## Application for Licence Amendment

| Licence Number           | L8345/2009/3   |
| <b>Premises</b>          | King of the Hills Gold Mine<br><br>LEONORA WA 6438<br><br>Legal description –<br><br>Part of mining tenements M37/67, M37/76, M37/90, M37/201, M37/222, M37/248, M37/330, M37/410, M37/429, M37/449, M37/451, M37/457, M37/547, M37/548, M37/572, M37/573, M37/574 and M37/1105<br><br>As defined by the Premises maps attached to the Revised Licence |
| <b>Date of Report</b>    | 28 April 2025  |

Figure 1: Wet plant upgrade (stage 1 in red, stage 2 in blue)

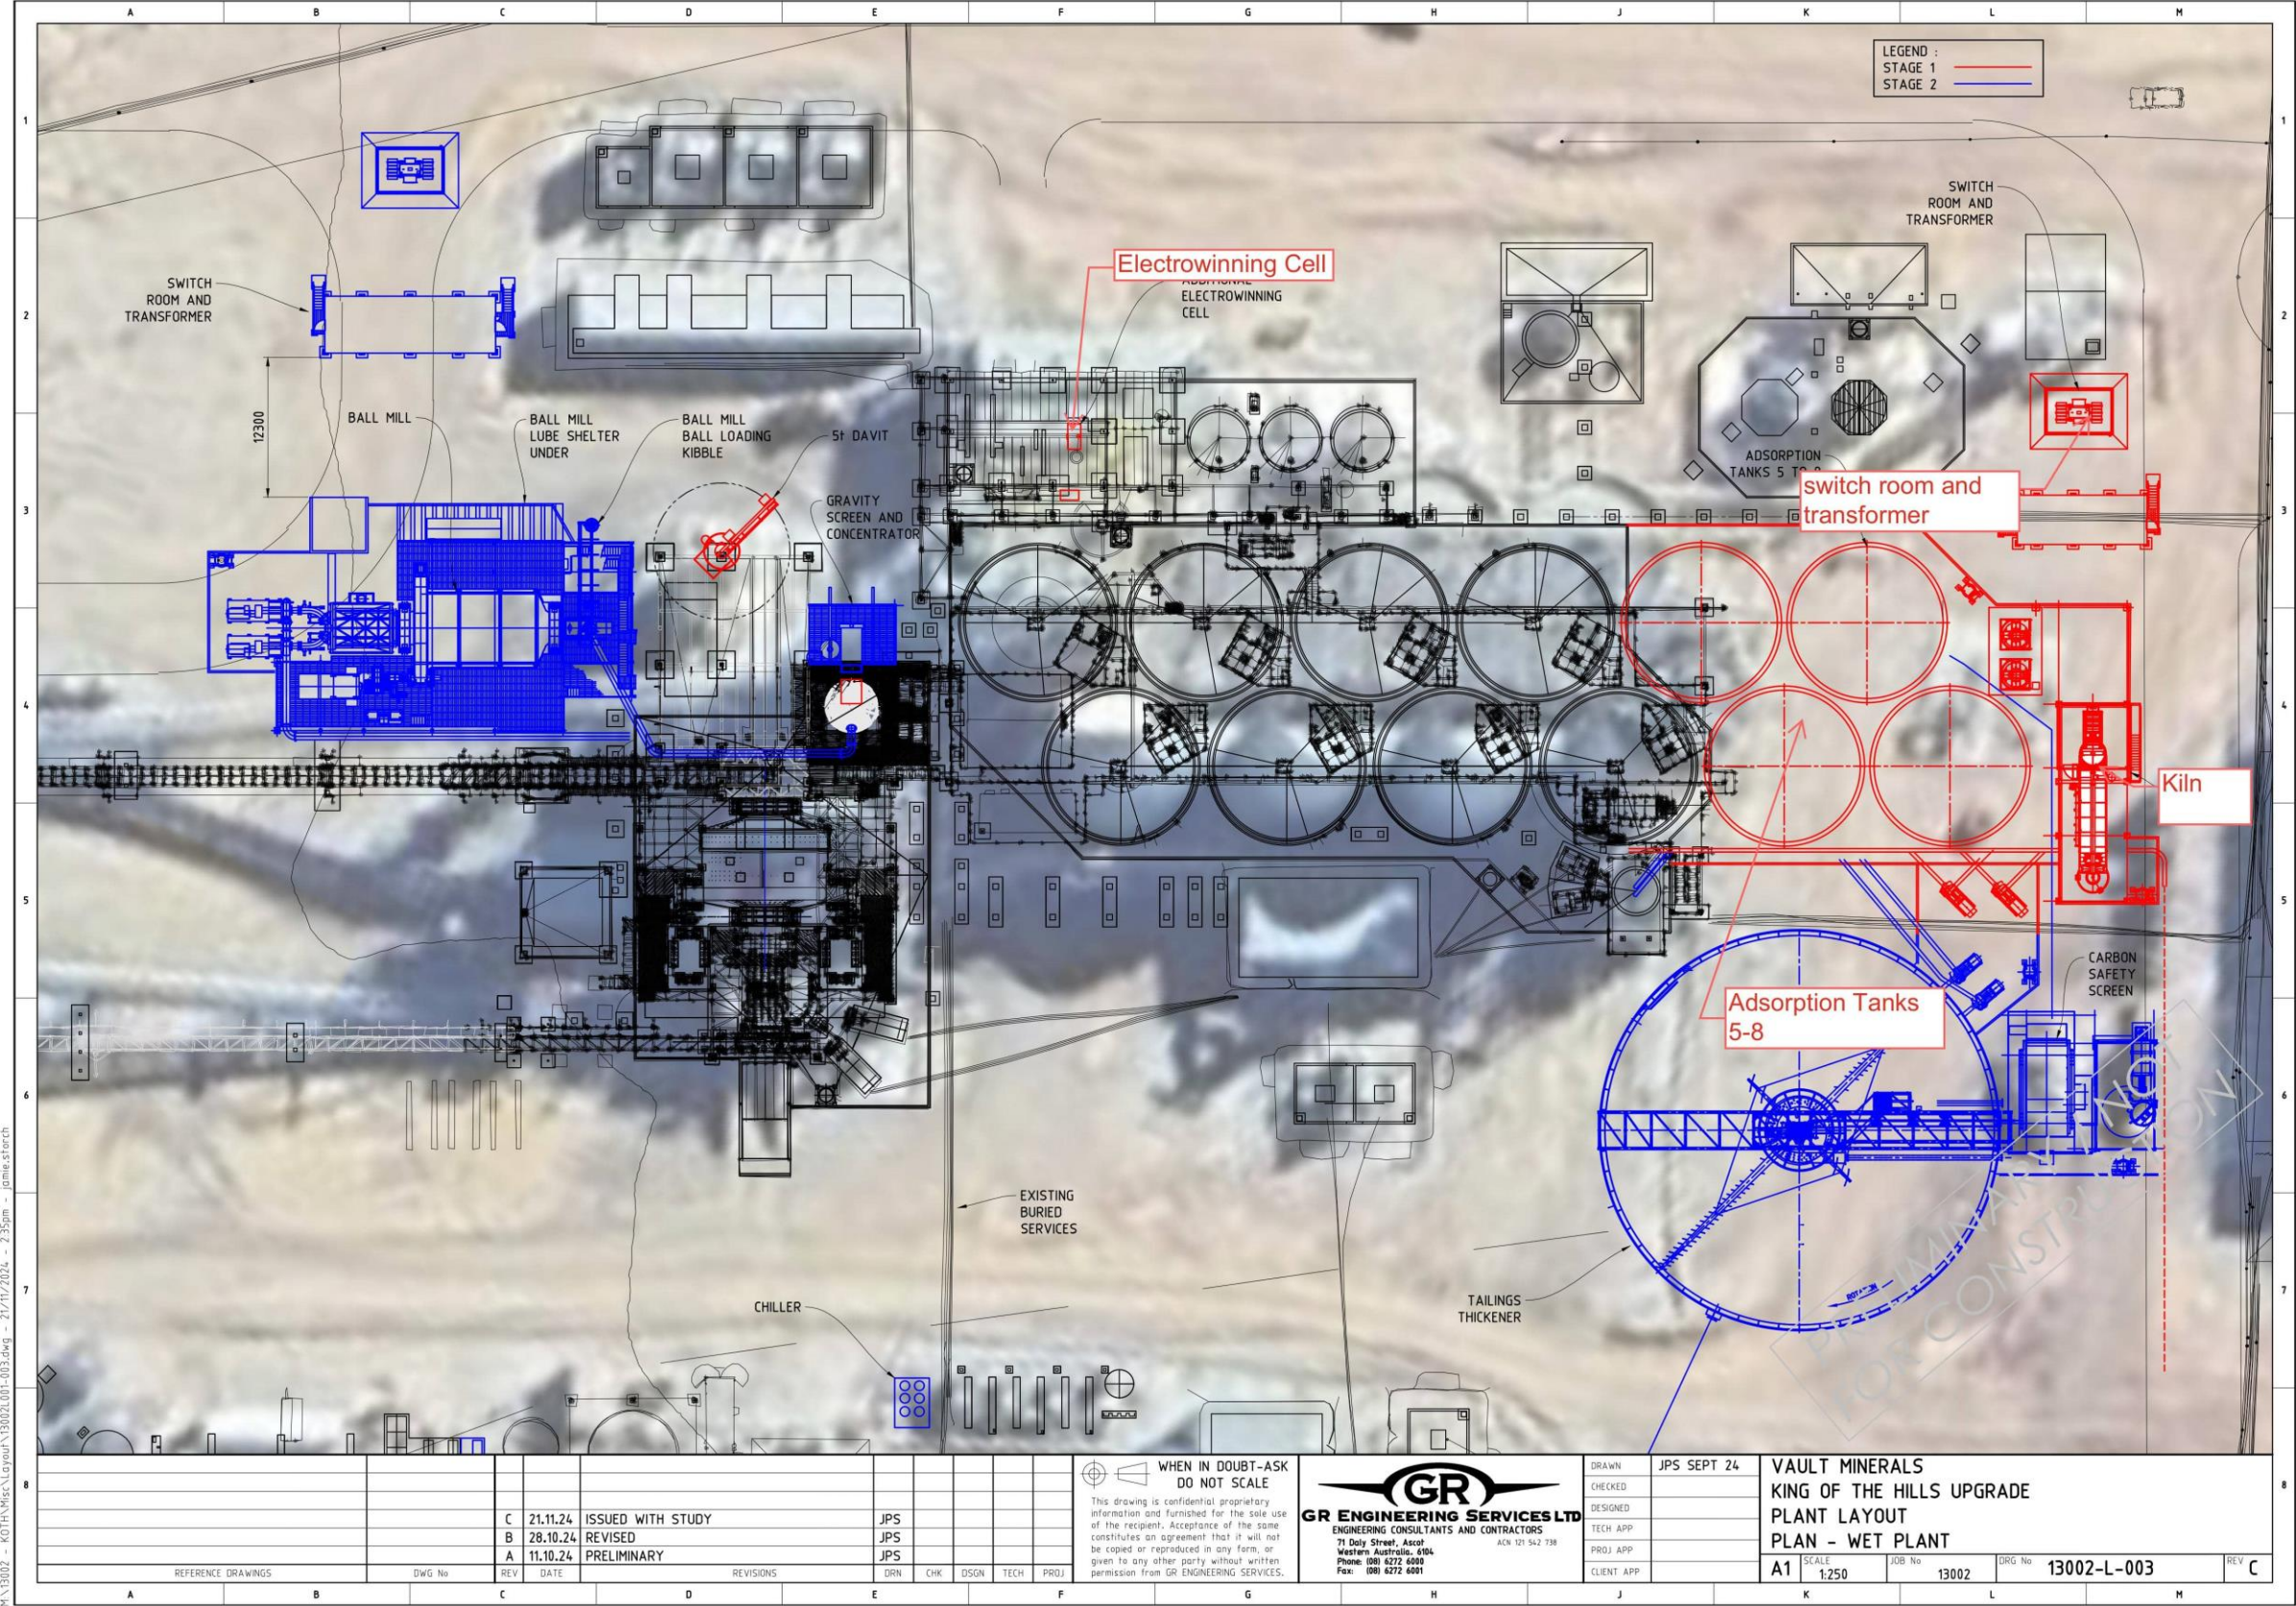
- Upgrade of existing lime silo feed arrangement (Figure 2)
- Installation of four additional adsorption tanks and ancillary equipment (Figure 1). This scope also includes the extension of the existing bunded area and the overhead crane to accommodate the additional tanks.

- Installation of one additional electrowinning cell (Figure 1)
- Installation of a new kiln in a new location and the removal of the existing unit (Figure 1)

Figure 2: Stormwater and crusher relocation

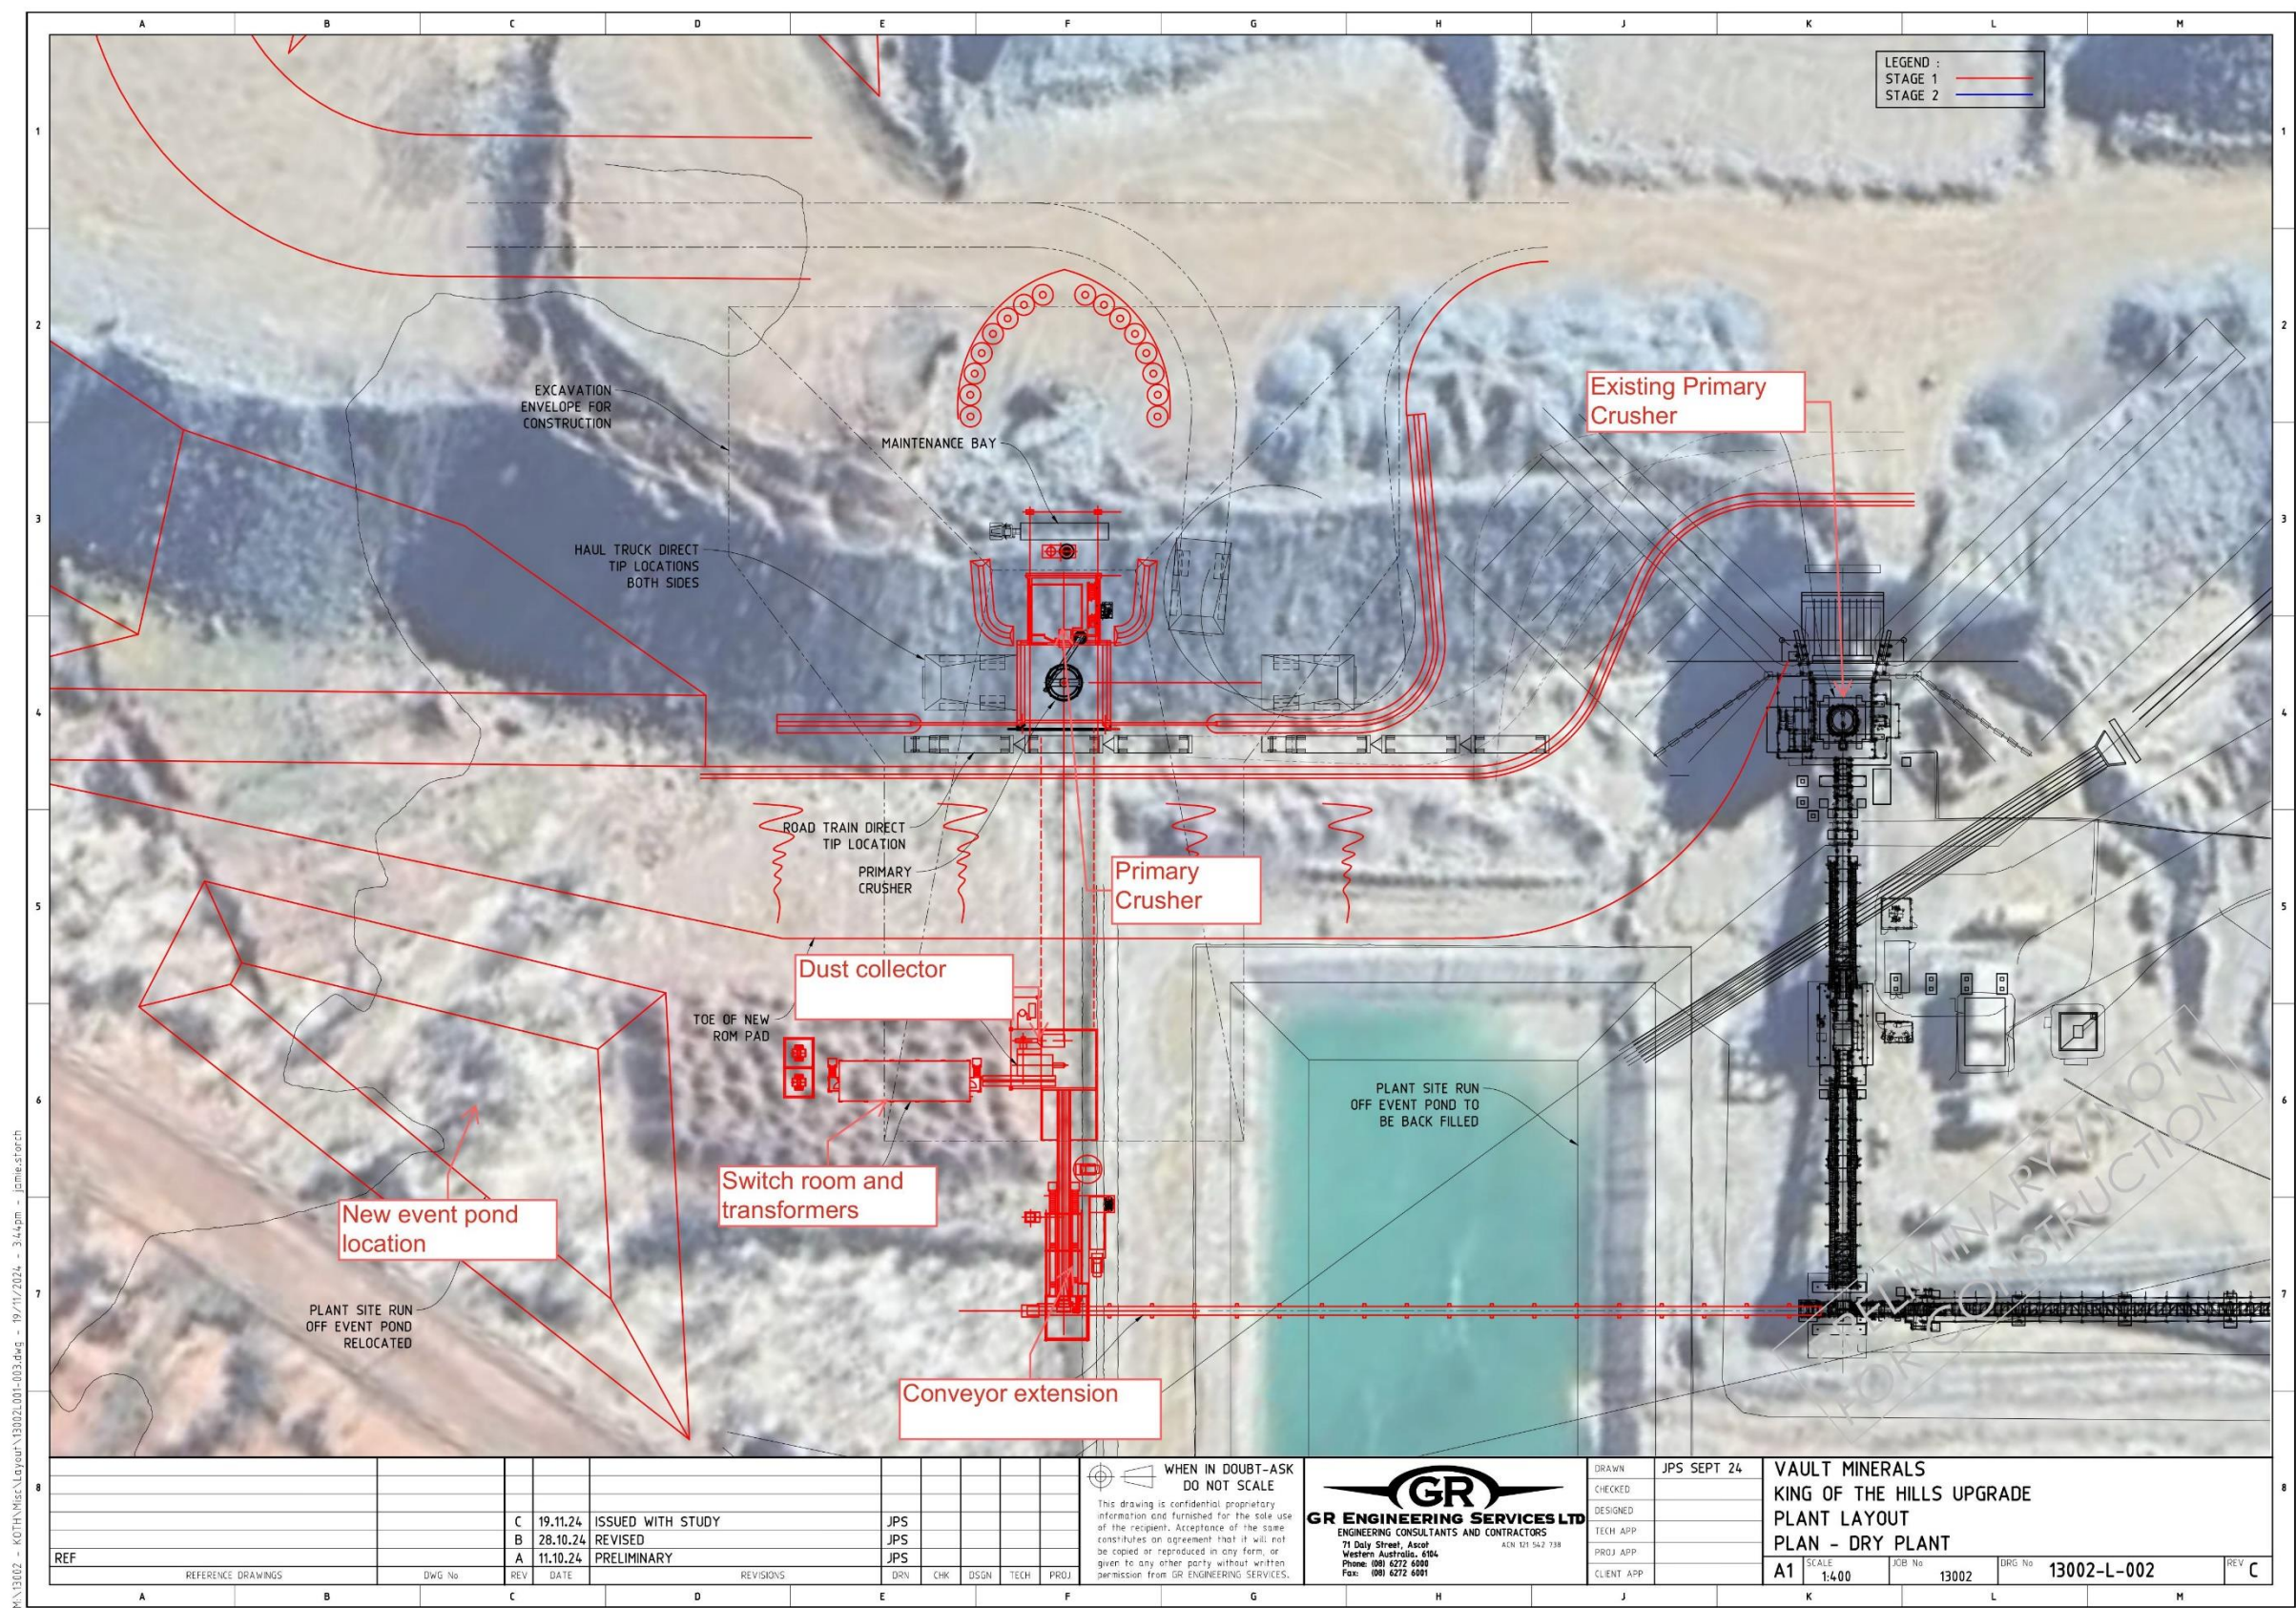
- Replacement of the primary crusher circuit (similar and adjacent to the existing crusher, replacing rather than supplementing it) to feed onto exiting Coarse Ore Stockpile (COSP) conveyor (Figure 2). This scope also includes installation of a 5T davit crane installed on the SAG Mill Feed deck and a fire suppression system installed in the COSP tunnel

- Relocation of stormwater pond associated with the crushing and screening plant to accommodate the replacement of the primary crusher circuit (Figure 2). The existing site run off water pond will be relocated to the west of the existing pond. Site run off drains will be redirected to the new pond and the stormwater retention capacity will remain the

same.
